Assignment 2 Analysis

Below is my first attempt at the design document, the one I received feedback on.

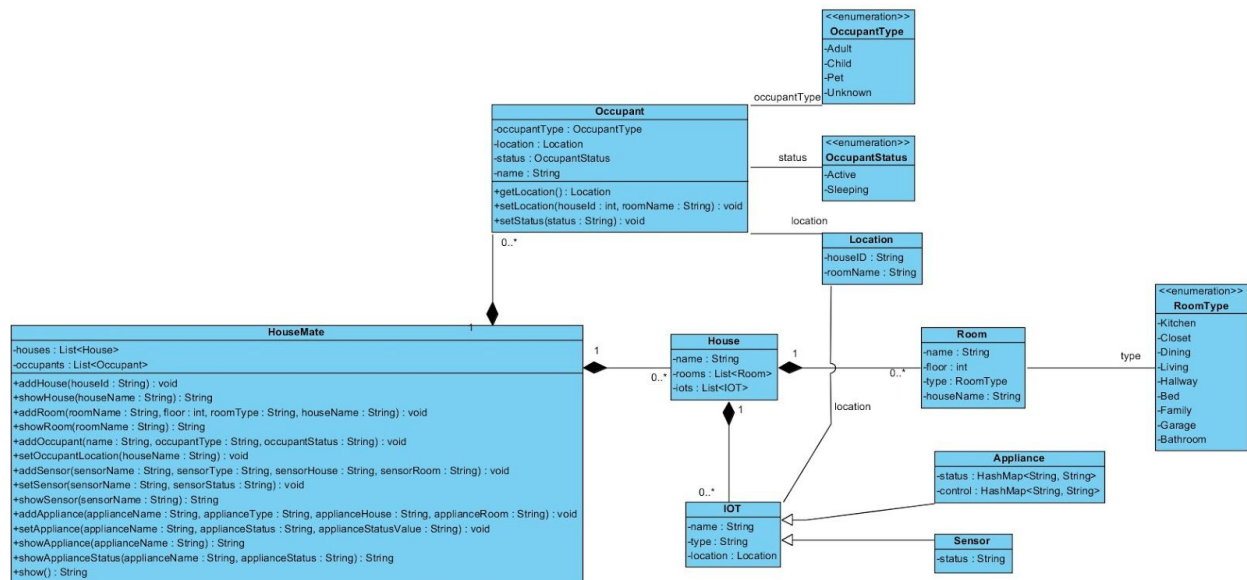
- Pull some methods out of HMMS, or at least have the HMMS be a pass through for objects like room / sensor. Then these methods can properly manage the attributes that belong to them.
- Also, that way you can error handle at the House level or lower and pass the error back up instead looking for where the error arises from in the HMMS.
- You don't need to include all getters/setters in a UML diagram.
- For printing the output, it makes sense for the HMMS to do it since the method is called "show"; it would be weird if it returned a value and didn't actually print it out.

- Removed the enums, too much to maintain + if they increase complexity, the overhead work increases from just 4 `OccupantTypes` to 10 or however it changes. Same for the other enums.
- I liked extracting the `addRoom` feature to house as rooms are an attribute of the house. I however didn't continue that idea for the IOTs because I wanted to see the difference in

design / implementation and see if either method was actually better for the system / code.

- I added in the Controller to the design.
- I also added custom toString() methods to all the main objects which allowed me to just toString() and concat each component when doing “show” methods. Example:
 - showHouse() = house.toString + each(room.toString) + each(IOT.toString).
 - or just showSensor(smoke_detector) = get(smoke_detector).toString
